<b>Subject:</b>  CHIRP NOISE FROM REAR SHOCK ABSORBERS	<b>Bulletin No:</b> 02-003/14
	<b>Last Issued:</b> 10/23/2014

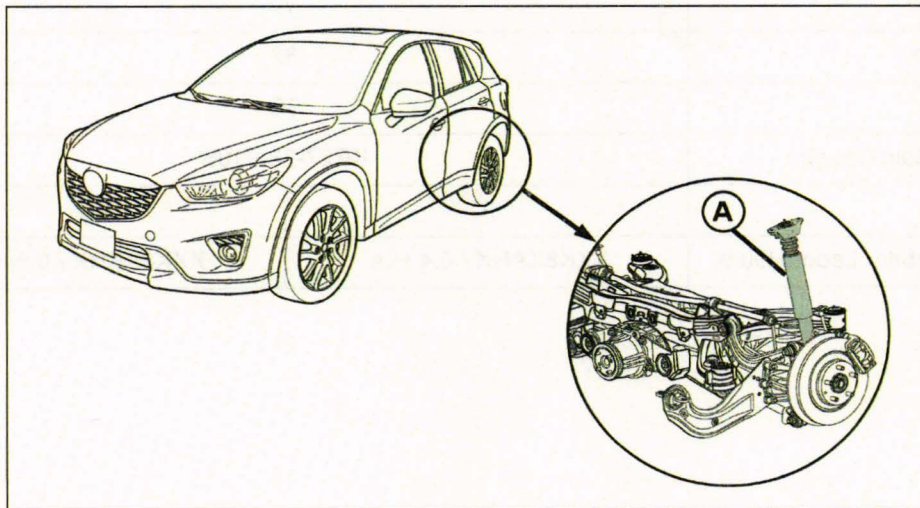
Some vehicles may exhibit a chirp noise from the rear shock absorbers (A) when driving on a rough road or passing over a speed bump. Visual inspection of the shock absorbers show no external damage or oil leakage.

1. Verify customer concern.
2. Replace the rear shock absorber. Refer to MS3 online or Workshop Manual (section 02-14 REAR SHOCK ABSORBER REMOVAL/INSTALLATION).

**NOTE:** Only replaced the affected side.
